Subject: Comments on Draft Regulatory Guide DG-1107, "Water Sources for Long-Term Recirculation Cooling Following a Loss-of-Coolant Accident"

**Comments on
Draft Regulatory Guide DG-1107
“Water Sources for Long-Term Recirculation Cooling Following a Loss-of-Coolant Accident”**

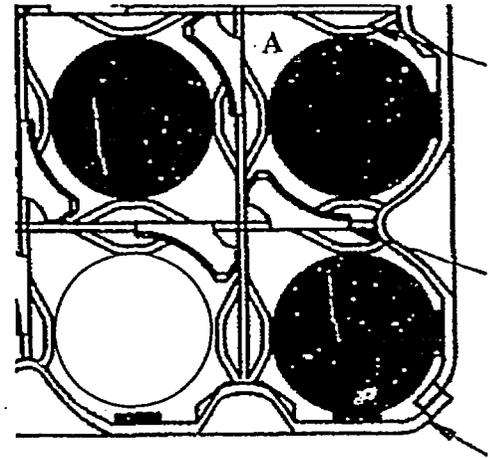
Based on the sump screen sizing requirements, it is suggested that it is not physically possible to develop a sump screen that would filter out debris that could potentially cause blockage concerns downstream of the ECC sump. For example, an illustrative top view portion of a fuel assembly mid-grid is provided in the figure to the right. If the coolant channel opening in the fuel assembly is identified channel 'A', then it can be shown, based on geometrical calculations, that the effective flow diameter of 'A' meets the sump screen sizing requirements at initiation for a post-LOCA long-term core cooling scenario. If fibrous material and paint chips/coatings are accounted for in an analysis, fibrous material may be considered to wrap around the components of a mid-grid (like hair around a strainer in a sink drain). With time, the build-up of this type of debris could potentially block the coolant channel opening. This example can be extended to other components downstream of the ECC sump, i.e., seals, bearings and impeller clearances.

Thus, given the set of boundary conditions and assumptions to be accounted for in the analysis, the requirement to show no blockage is not possible.
